FAKIR KNITWEARS LTD. (Extension - 2)

22 December 2024

Structural Inspection Report

Figure: Roof Top floor Beam reinforcement (in') of the building

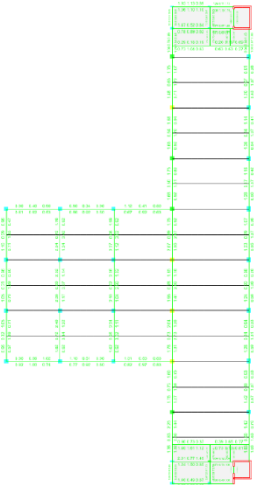
Observation 01: Inconsistency in the design report [Building-12 (All Over Printing Building)]

Description: The prepared design report did not include steel connection design and member adequacy checks. Irregularity checks were missing in the report. Moreover, the steel pipe material test report was not available during the inspection. The building engineer is required to verify in-situ steel material strength and include all necessary checks in the design report in compliance with BNBC (part-6, section 1.9.1) requirements. Submit the revised design documents to the RSC for detailed review against lateral forces.

SL	Observation	Action Plan	Timeline
1.	Inconsistency in the design report [Building-12 (All Over Printing Building)]	The building engineer is required to verify in-situ steel material strength and include all necessary checks in the design report in compliance with BNBC (part-6, section 1.9.1) requirements. Submit the revised design documents to the RSC for detailed review against lateral forces.	within 6 weeks

FOURTH FLOOR LOAD PLAN
SCALE NTS

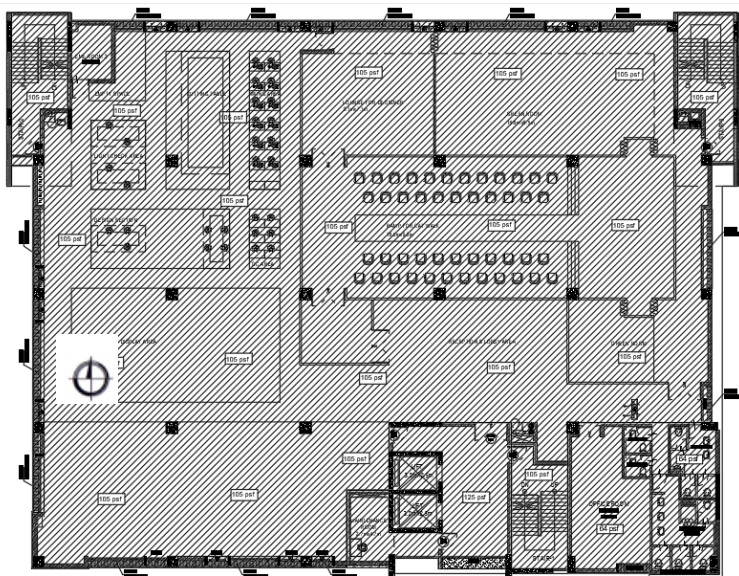
Observation-06: Inconsistencies in as-built drawing. (Building-13 (New Printing Building))

Description: During the inspection, store (125 psf) was found on the 4th floor but in the load plan it was mentioned as studio (105 psf). The building engineer is required to update the as-built drawing according to site conditions, revise the load plan as per BNBC requirements and check the design accordingly.

7.	Inconsistencies in as-built drawing. (Building-13 (New Printing Building))	The building engineer is required to update the as-built drawing according to the as-built condition, revise the load plan as per BNBC requirements.	within 6 weeks
